City of Bay Minette

Planning Commission

AGENDA

February 9, 2023

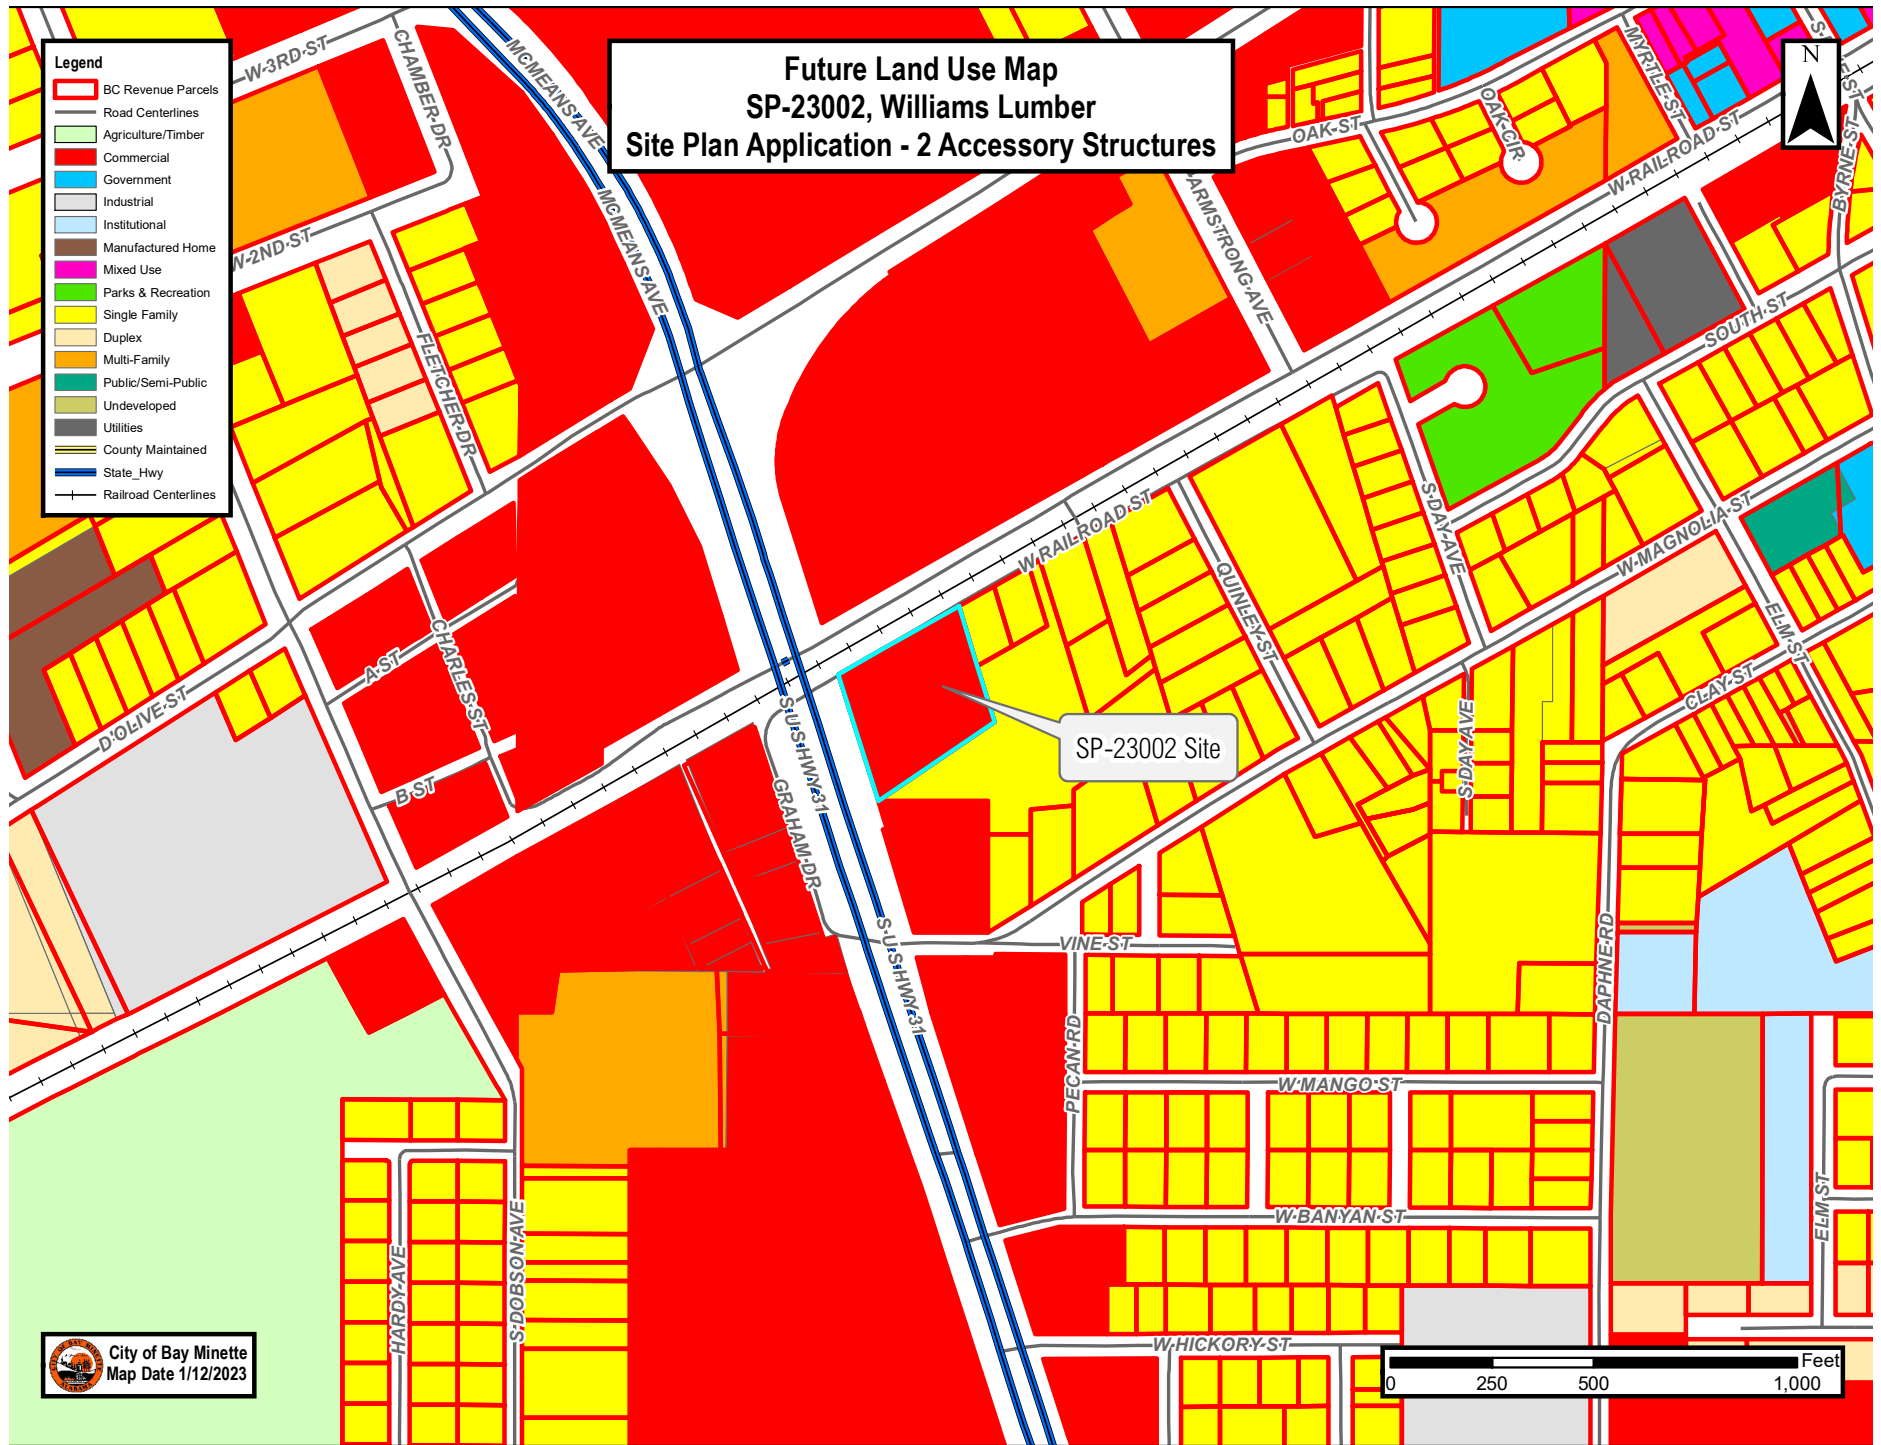
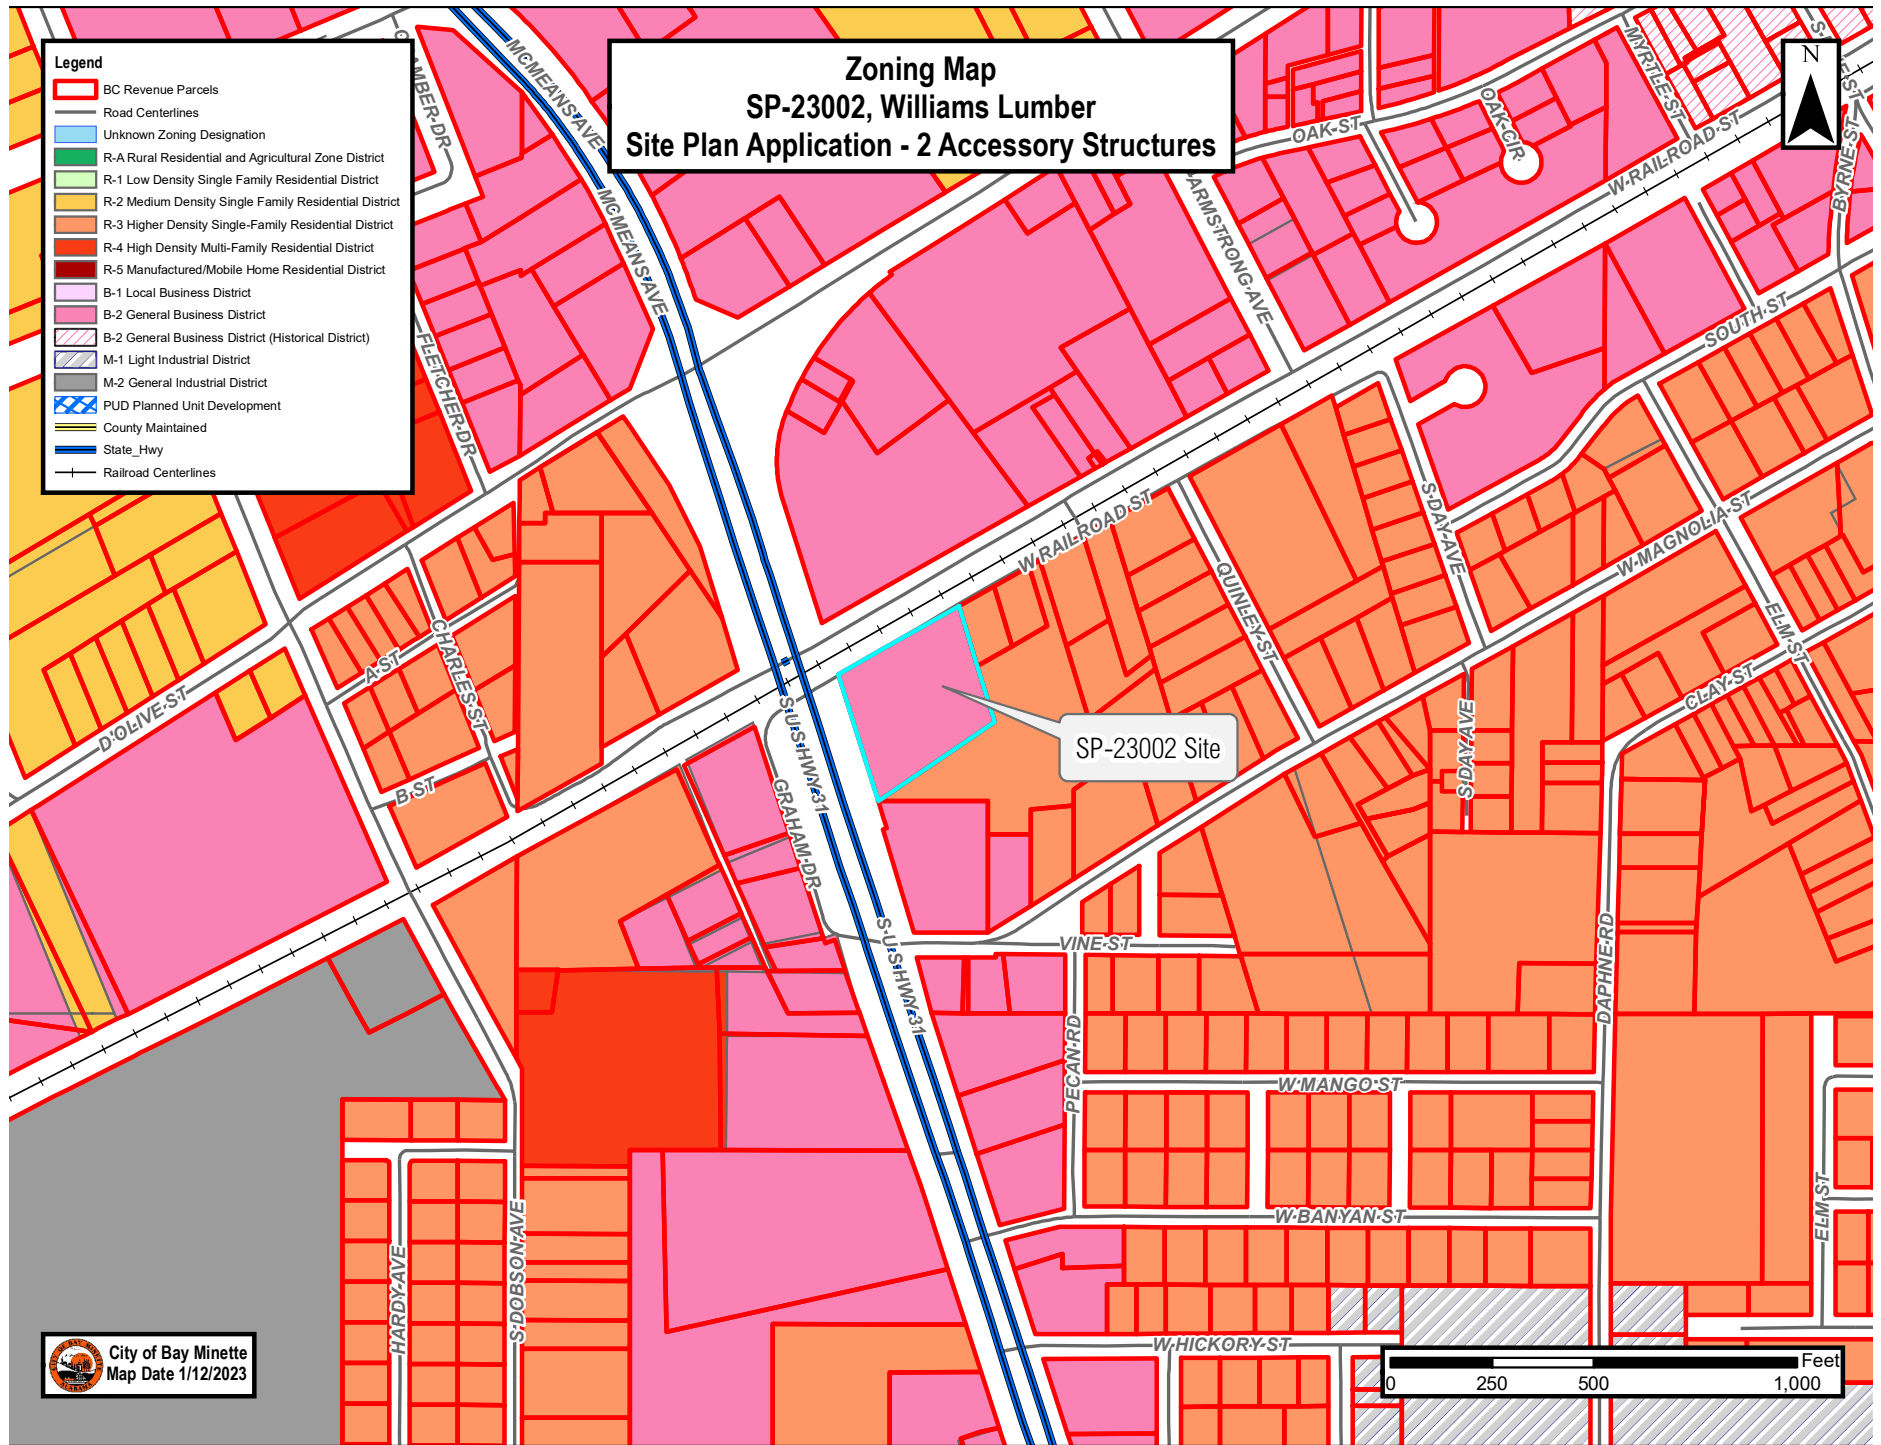
The proposed site plan shows a building footprint of 24'x36' (864 sq ft) for the pole barn which the applicant stated would have a 10ft eave height; and a 24'x80' (1,920 sq ft) lean-to with a front height of 16ft and angled back to the rear/south side. Both structures will be open storage - the pole barn will be roof only and the lean-to will have a wall on the south side.

For this property, the B-2 district requires 25ft front setbacks on local roads and there are no required setbacks for the side and rear yard except when abutting a residential district, the setback cannot be less than 20ft. The original site plan submitted shows setbacks that are not in compliance with this, however, the applicant has stated that the lean-to will be 20ft or more from the rear property line. The side setback dimensions shown on the site plan ranging from 5' to 15' are stating the distance from the existing chain-link fence, which is shown approximately 37' from the property line as estimated from GIS. The graphics included in this section were created by staff to approximate the proposed locations for existing site features and proposed structures. It is an estimate based on submittals and communication with the applicant intended to provide an illustrated guide to assist the Planning Commission.

The illustrations show a potential conflict with the pole barn and existing trees. Based on the revisions to the submitted site plans and clarification needed for structure location and final driveway/parking area size, staff would recommend that the applicant submit a Site Plan detailing final locations and dimensions at the time of Building Permit application.

- 1.) Submittal of a Site Plan detailing final locations and dimensions for staff review prior to the issuance of a Building Permit.
- 2.) The issuance of a Building Permit be contingent upon access review by ALDOT or the City Engineer based on ALDOT's review and determination of access authority.

**SP-23002 Williams Lumber
711 W Railroad Street
Site Plan Access Map**

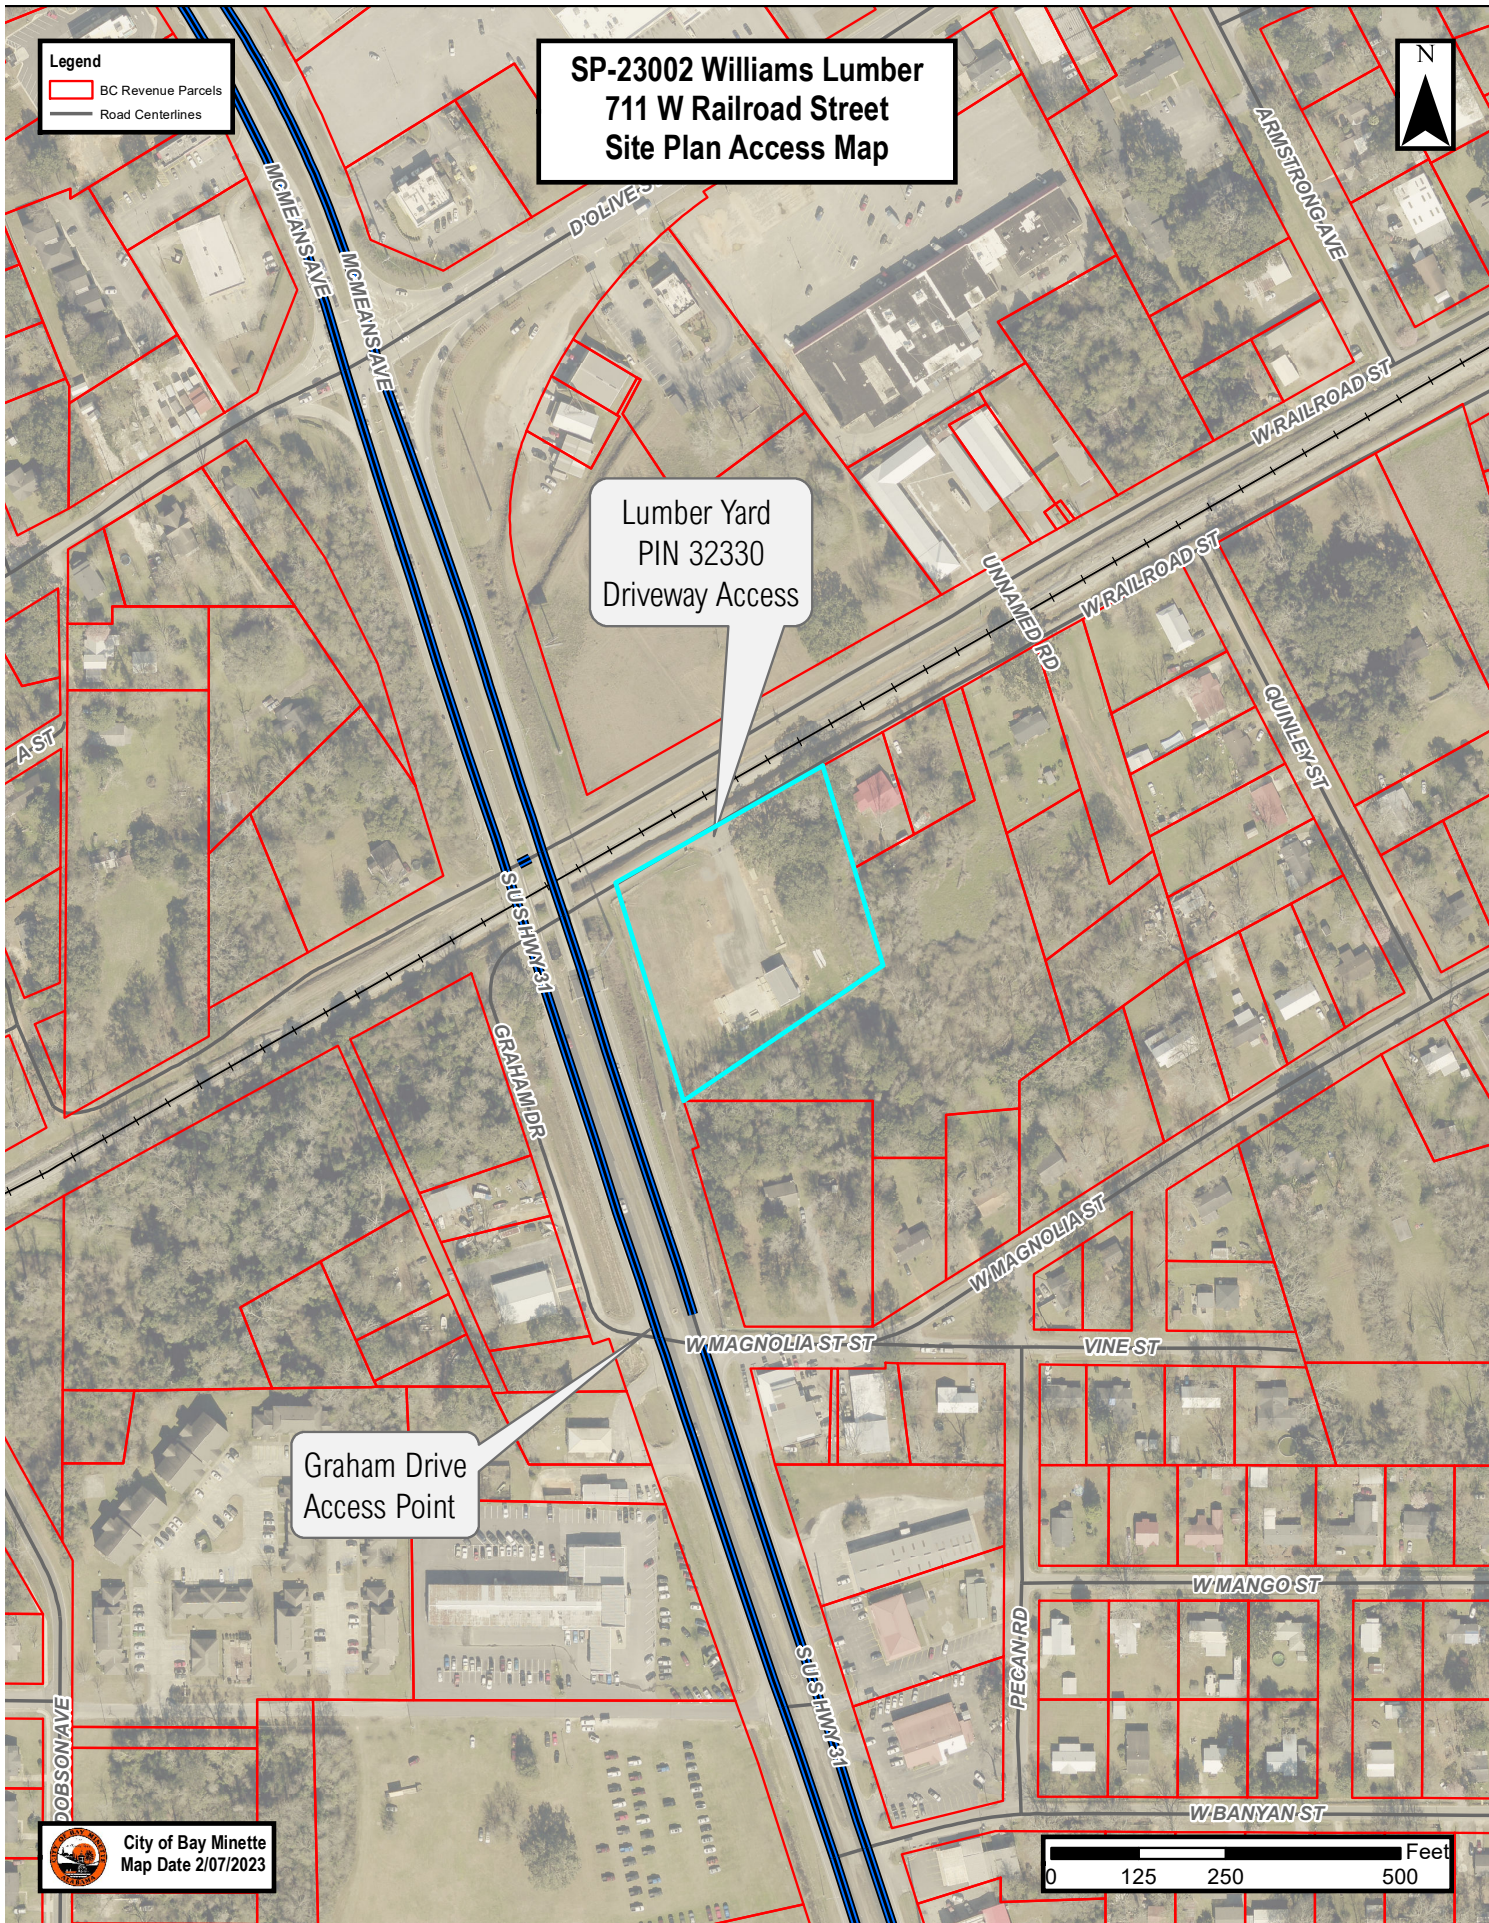
This site is accessed from Graham Drive. The W Railroad St access is where CSX ROW and private property join, and the City has no authority to allow access to those properties along this area. Graham Drive does appear to be located within ALDOT's ROW and staff is working with ALDOT to verify. At this time, ALDOT's Area Permit Manager, Michael Smith, P.E., does not believe the State has any roadway designation for this section, but is verifying the maintenance authority for this section. He agreed that the City should review it as City's ROW until confirmation from the State and include a condition that the applicant's approval be contingent upon any ALDOT concerns that may arise. If the City is determined to be the access authority, the application will be submitted to the City's Traffic Engineer for review.
